Regional Water Quality Control Board
Central Valley Region

Response to Written Comments for
Tentative Waste Discharge Requirements
for
County of Fresno
Coalinga Solid Waste Disposal Site, Fresno County

Figure 1: Surface Water

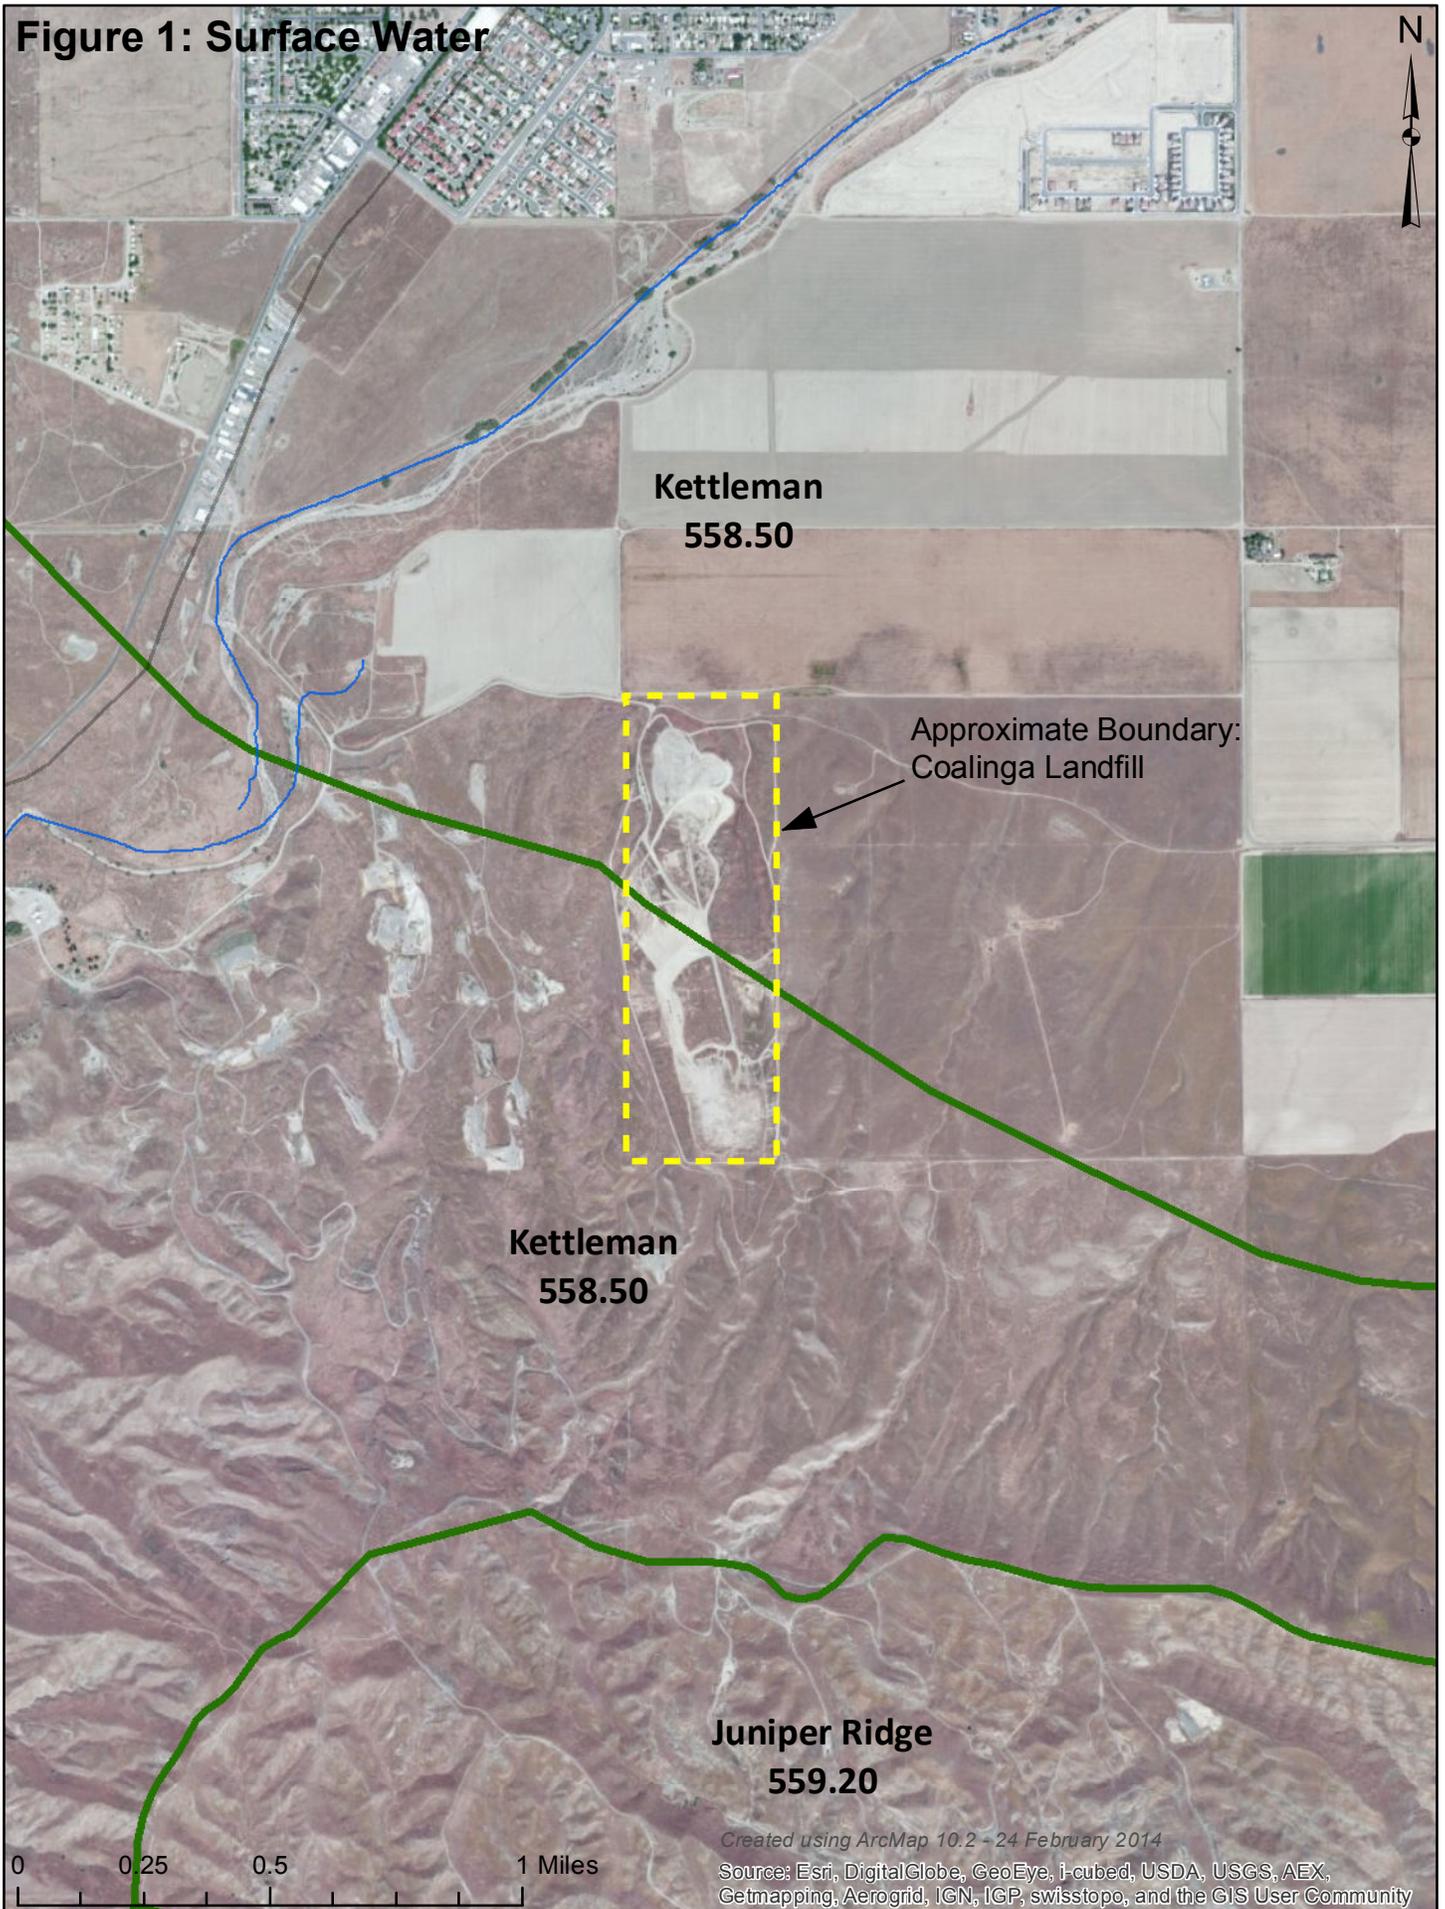
Comment: The current WDRs No. 5-00-233 (Finding 14) correctly identifies the facility located on bedrock in the Jacilitos Hills as part of the Juniper Ridge Hydrologic Area (559.20) west of Pleasant Valley. The entire Pleasant Valley Groundwater Basin, a part of the Kettleman Hydrologic Area (558.50), is within the Pleasant Valley Water District. The Pleasant Valley Water District boundary coincides with the Recent age alluvial floor of the valley and the Pleasant Valley Groundwater Basin does not extend off the valley floor into the Jacilitos Hills. (See Figures 1 through 3) We recognize that the facility is adjacent to the Pleasant Valley Basin (Tulare Lake Basin Detailed Analysis Unit 245) and also was recognized by the RWQCB in the first sentence in Finding 20 of the current WDRs No. 5-00- 233 that states “The site is adjacent to Pleasant Valley.” Warthan Creek is the closest surface body to the facility however the waste management facility is designed to capture and retain all stormwater on site. We propose the following change to Finding 21: *Near the facility, surface drainage in the Jacalitos Hills, part of the Juniper Ridge Hydrologic Area (559.20) is to the north towards Warthan Creek. Warthan Creek, is the closest surface water body about one half mile from the waste management facility boundary. Warthan Creek is an intermittent West Side Stream that flows from the Juniper Ridge Hydrologic Unit into Pleasant Valley, a part of the Kettleman Hydrologic Area.*

An analysis of the facility location was performed using the Watershed Mapper (an online tool) and ArcMap 10.2 (GIS), which was not available at the time the previous WDRs were developed. This analysis indicates that the facility is completely within the Kettleman Hydrologic Area (558.50) (See attached Figure 1). The boundary for the Juniper Ridge Hydrologic Area is over 0.5 miles south of the site. Finding 21 is adequate and will not be modified.
